RSL LifeCare Montgomery Centre ANZAC Village DA SUBMISSION

REVISION NOTES:
Revision Cloud 1 = Deletion of previously proposed mechanical exhausts stacks (x2), condenser platform, and access ladder.
Revision Cloud 2 = Previously proposed platform for mechanical condensers shifted from west to east. Louvred screen to conceal condensers added to south and west facing side of platform.
Revision Cloud 3 = Stairs increased width and the ramp moved next to the existing building.
Revision Cloud 4 = Parking near the Memorial Stage and planter walls design amendments.
Revision Cloud 5 = View of southern side of hall shows of deletion of previously proposed mechanical exhausts stacks (x2), platform, and access ladder. Louvred screen to conceal condensers platform can be seen.
Revision Cloud 6 = Finishes materials added
Revision Cloud 7 = Previously Anzac memorial was demolished. New proposal to retain the existing Anzac memorial and extend as represented in the proposed plans.

project Anzac Village-Montgomery Centre		date 7/5/2025	revision issue 06
project number 23010	client RSLLC	drawing scale @ A1	drawing number A000
drawing COVER PAGE

DEMOLITION GROUND FLOOR PLAN
1:200

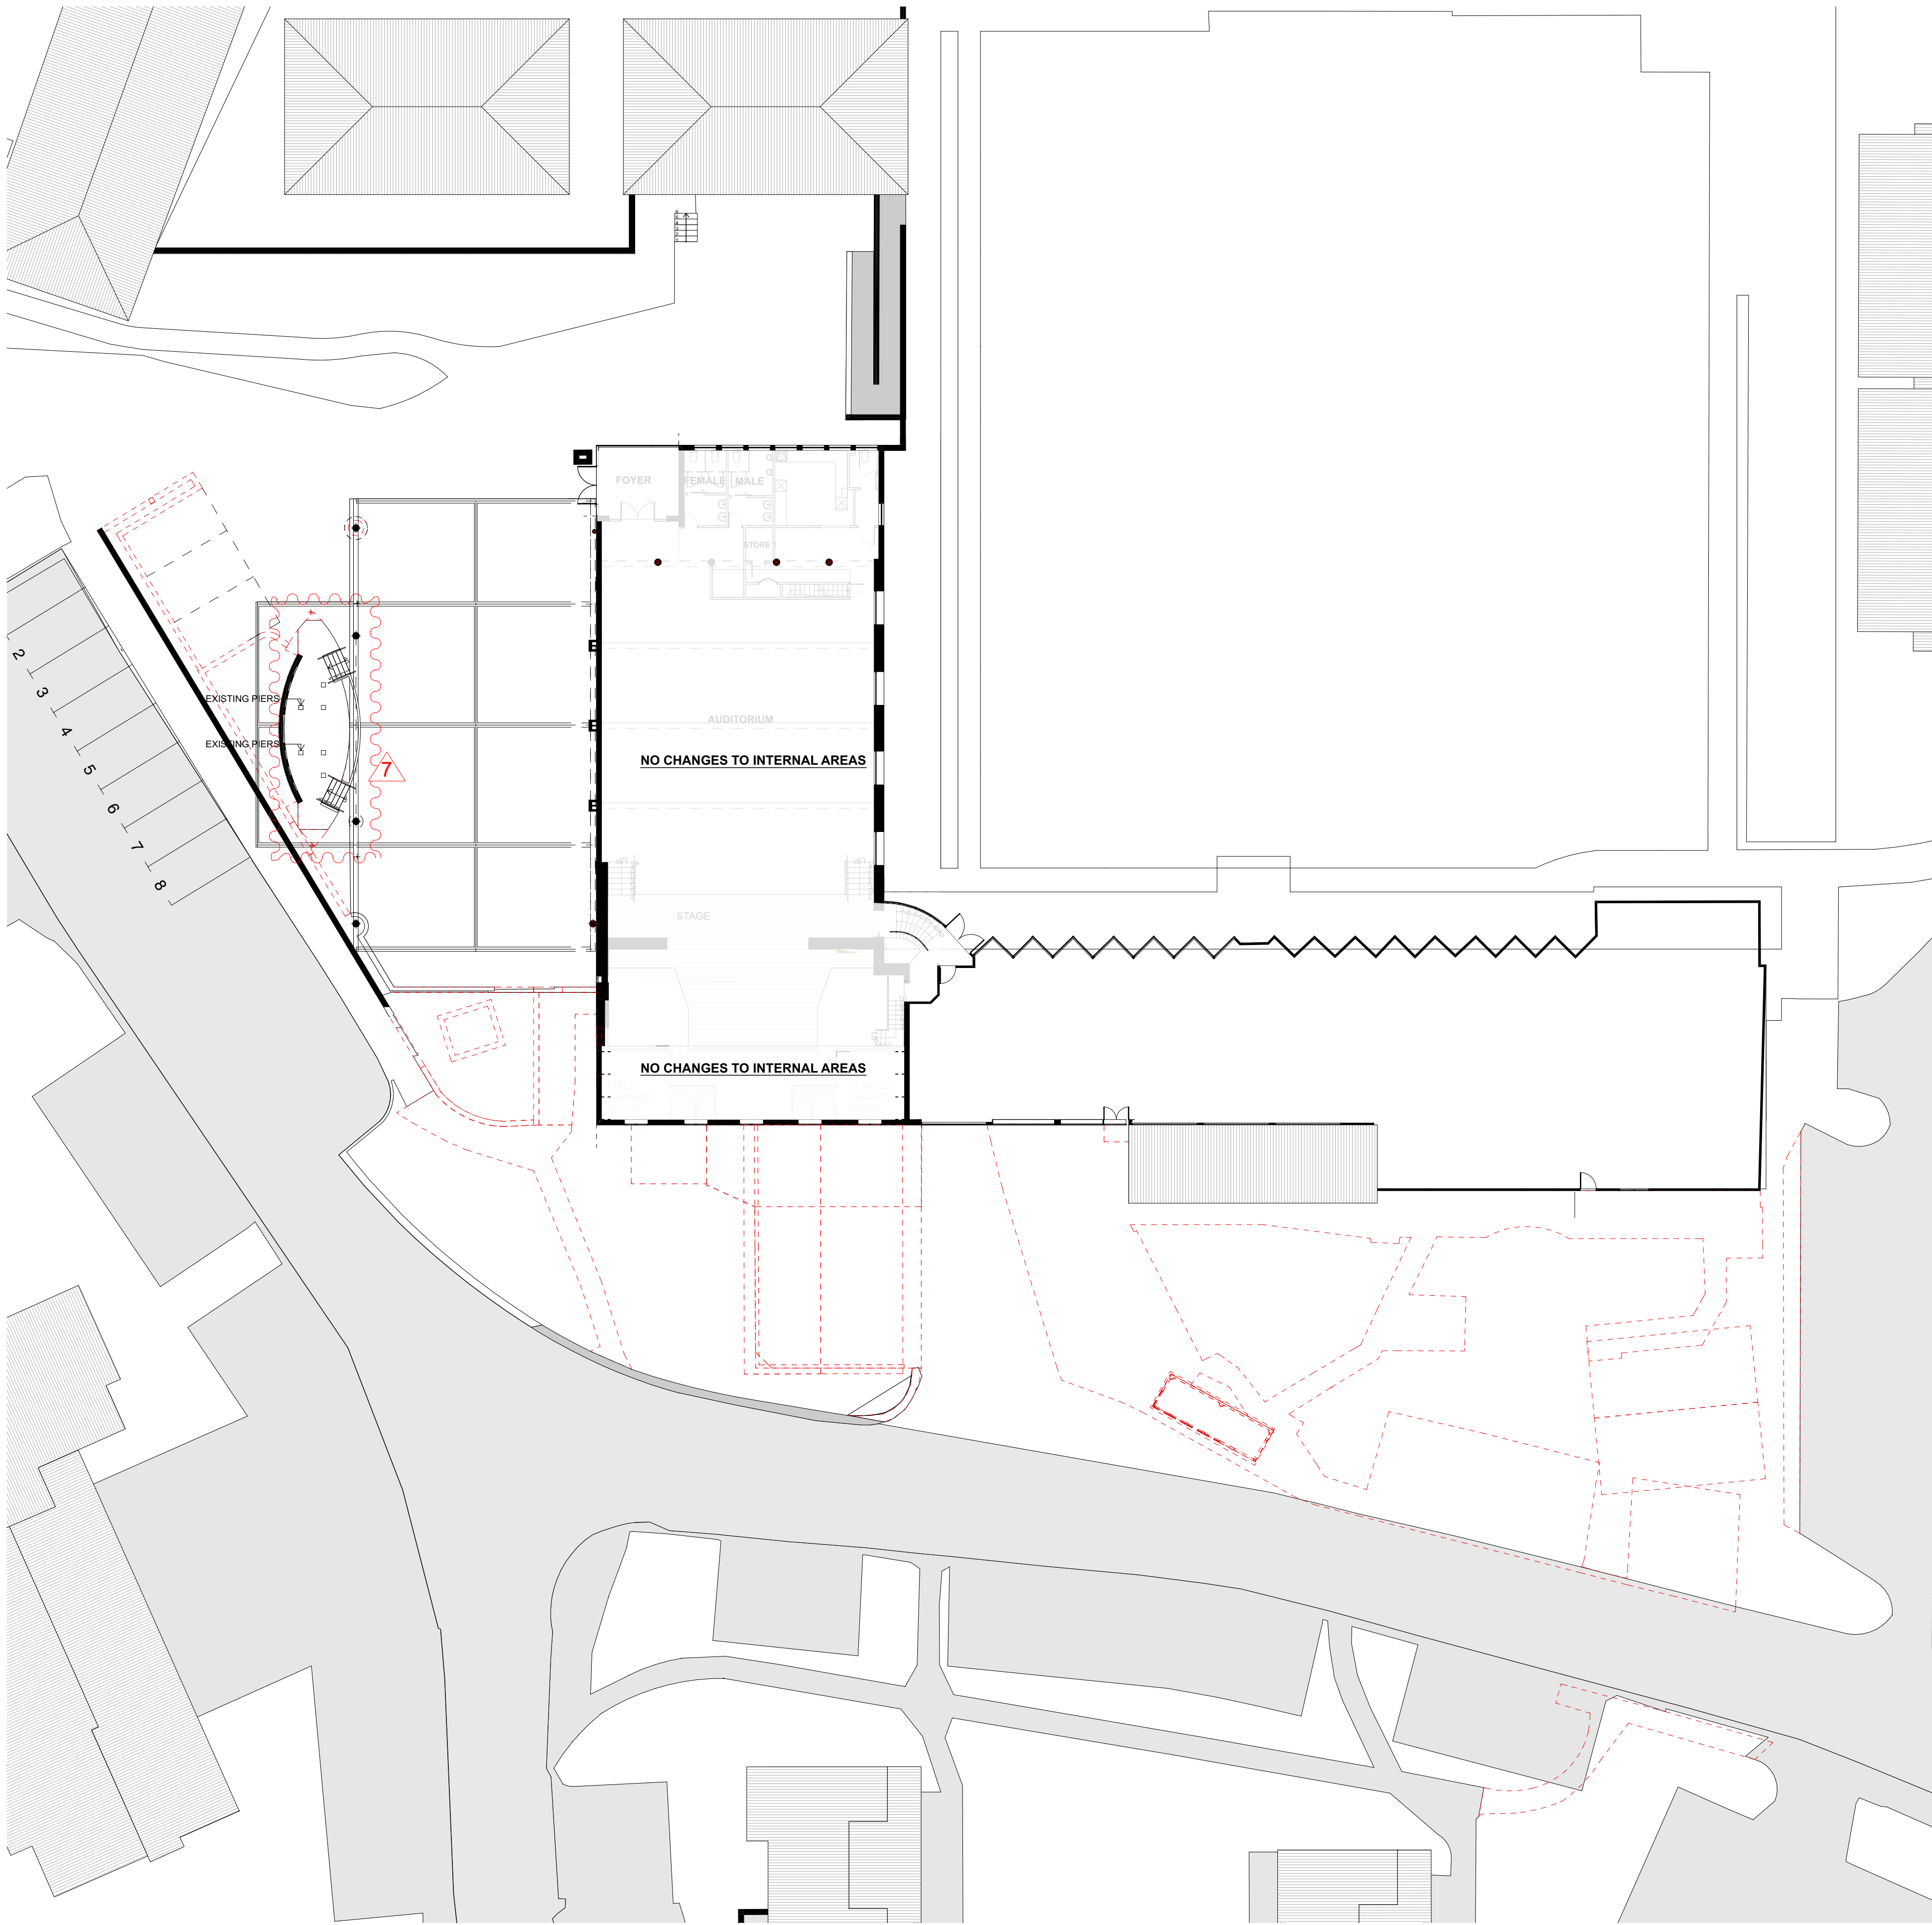
REVISION NOTES:
Revision Cloud 1 = Deletion of previously proposed mechanical exhausts stacks (x2), condenser platform, and access ladder.
Revision Cloud 2 = Previously proposed platform for mechanical condensers shifted from west to east. Louvred screen to conceal condensers added to south and west facing side of platform.
Revision Cloud 3 = Stairs increased width and the ramp moved next to the existing building.
Revision Cloud 4 = Parking near the Memorial Stage and planter walls design amendments.
Revision Cloud 5 = View of southern side of hall shows of deletion of previously proposed mechanical exhausts stacks (x2), platform, and access ladder. Louvred screen to conceal condensers platform can be seen.
Revision Cloud 6 = Finishes materials added
Revision Cloud 7 = Previously Anzac memorial was demolished. New proposal to retain the existing Anzac memorial and extend as represented in the proposed plans.

PROPOSED SITE PLAN
1:200

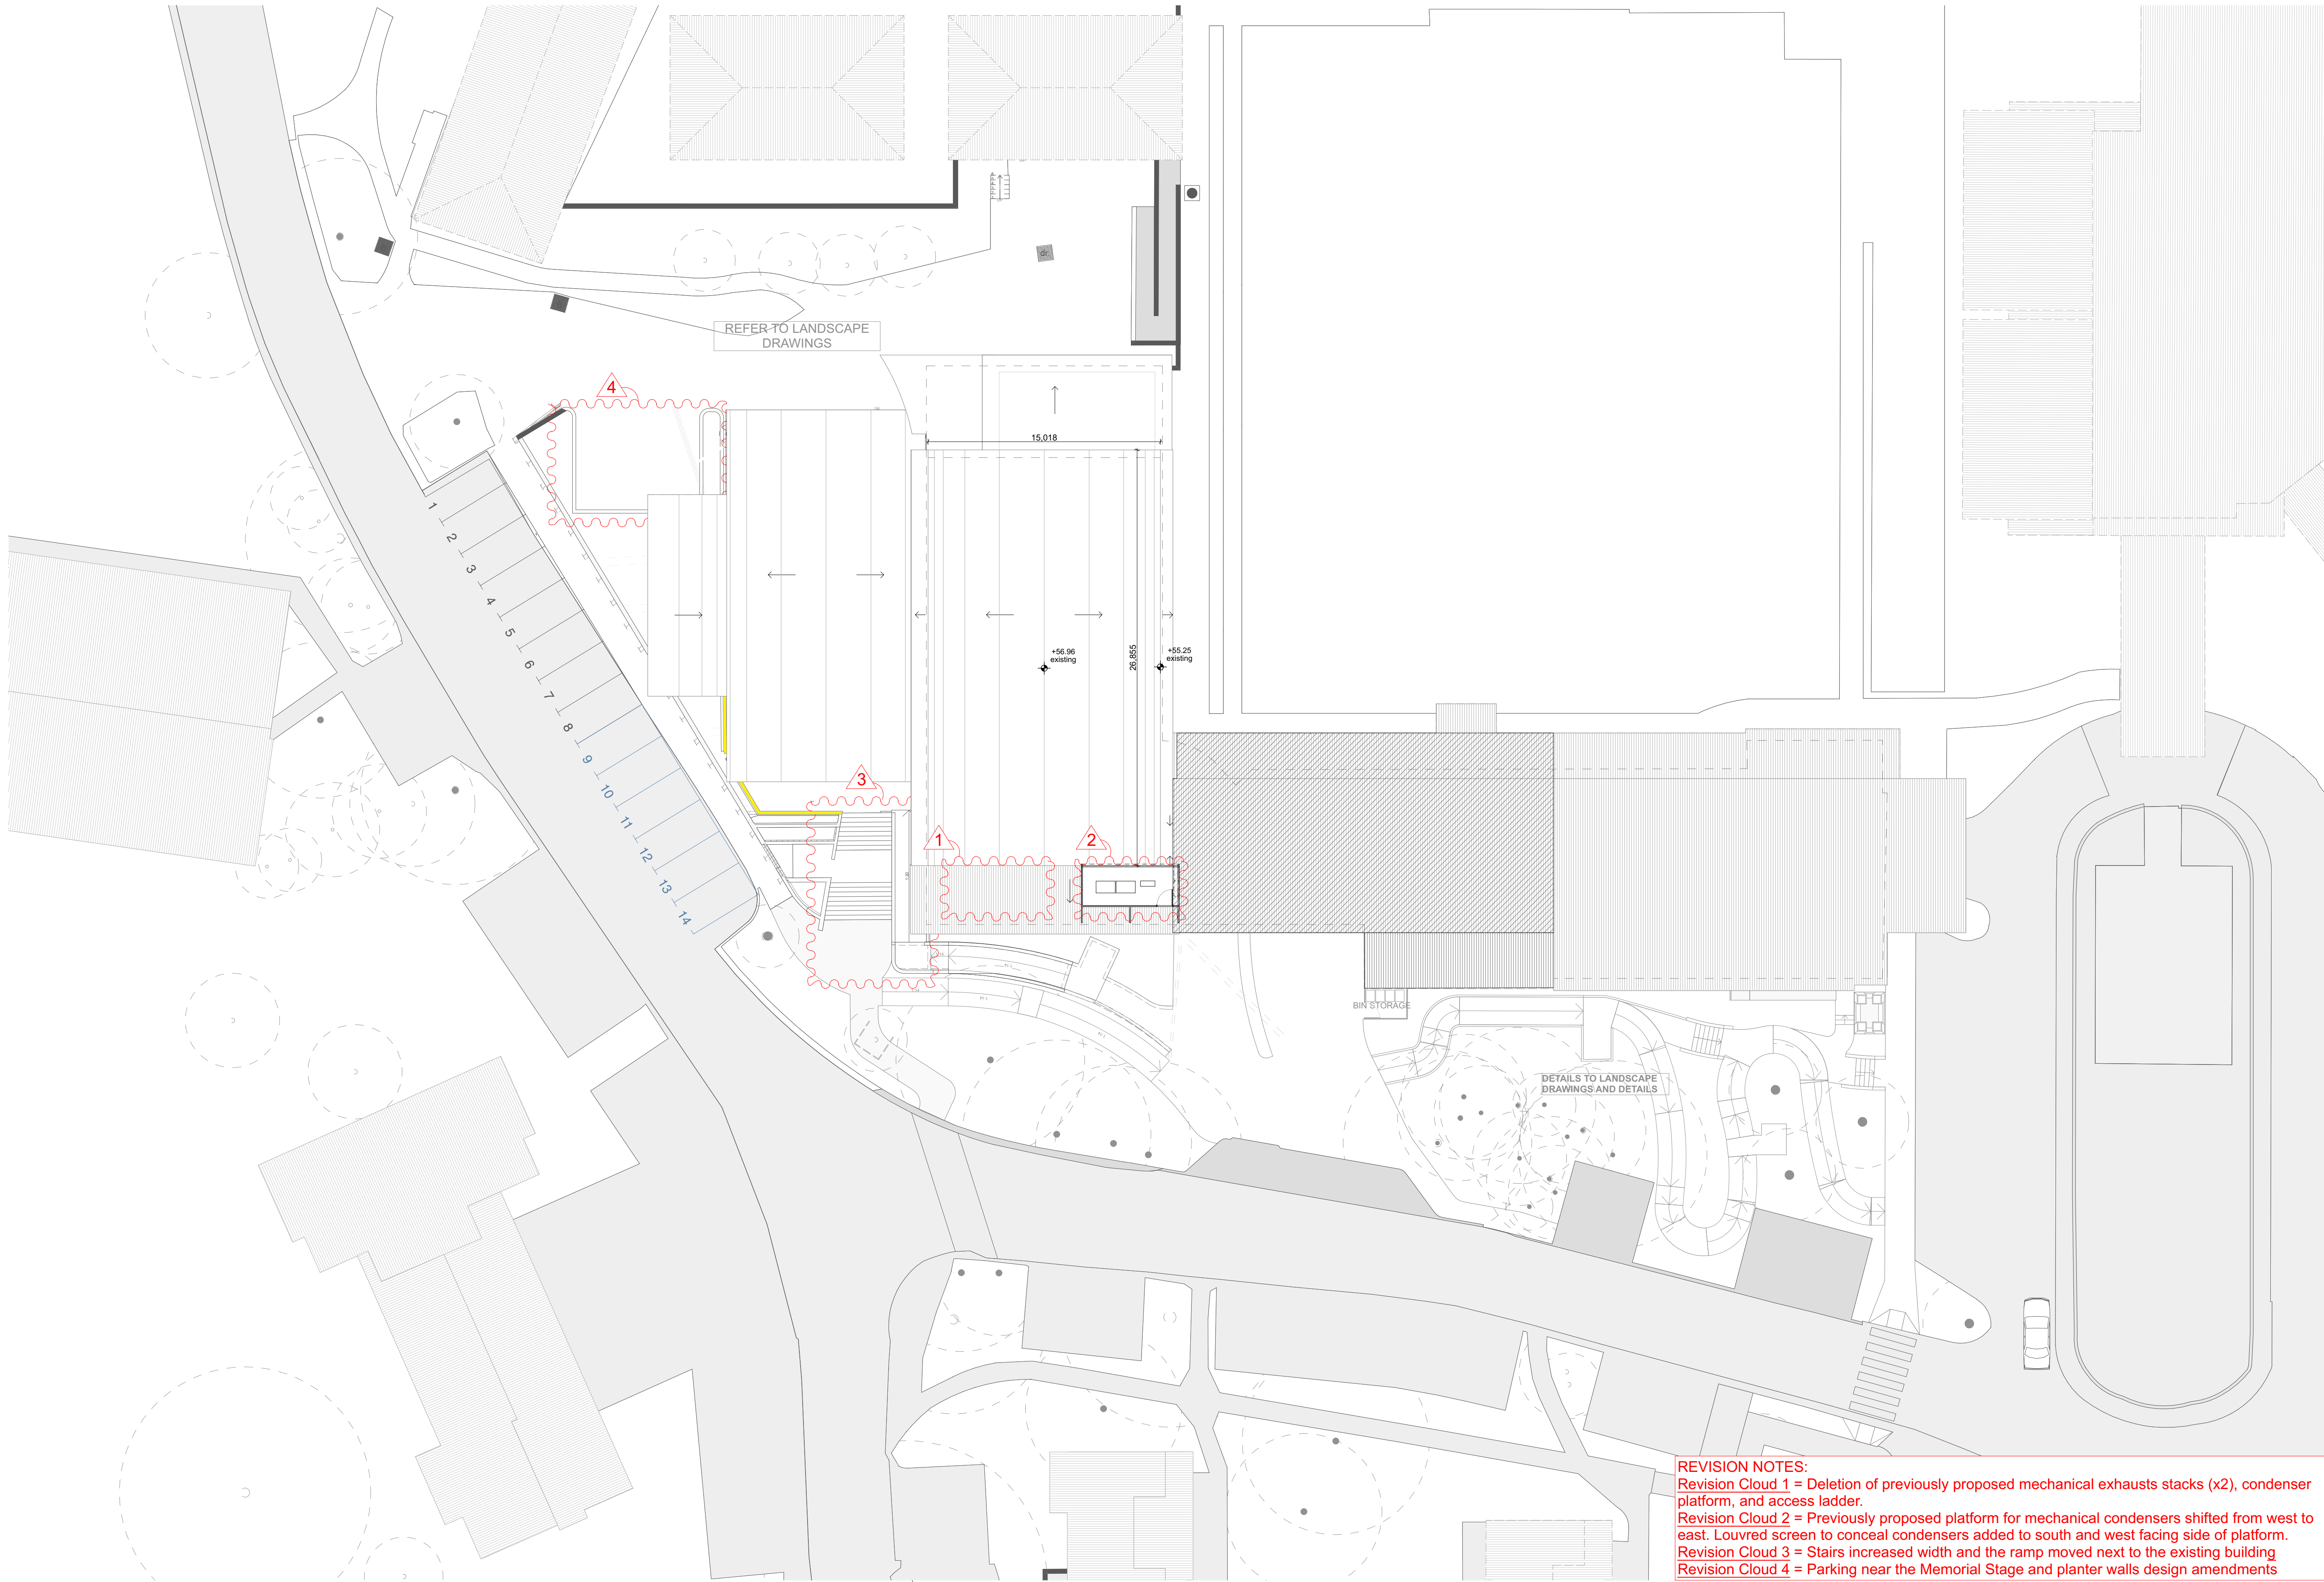
REVISION NOTES:
Revision Cloud 1 = Deletion of previously proposed mechanical exhausts stacks (x2), condenser platform, and access ladder.
Revision Cloud 2 = Previously proposed platform for mechanical condensers shifted from west to east. Louvred screen to conceal condensers added to south and west facing side of platform.
Revision Cloud 3 = Stairs increased width and the ramp moved next to the existing building
Revision Cloud 4 = Parking near the Memorial Stage and planter walls design amendments
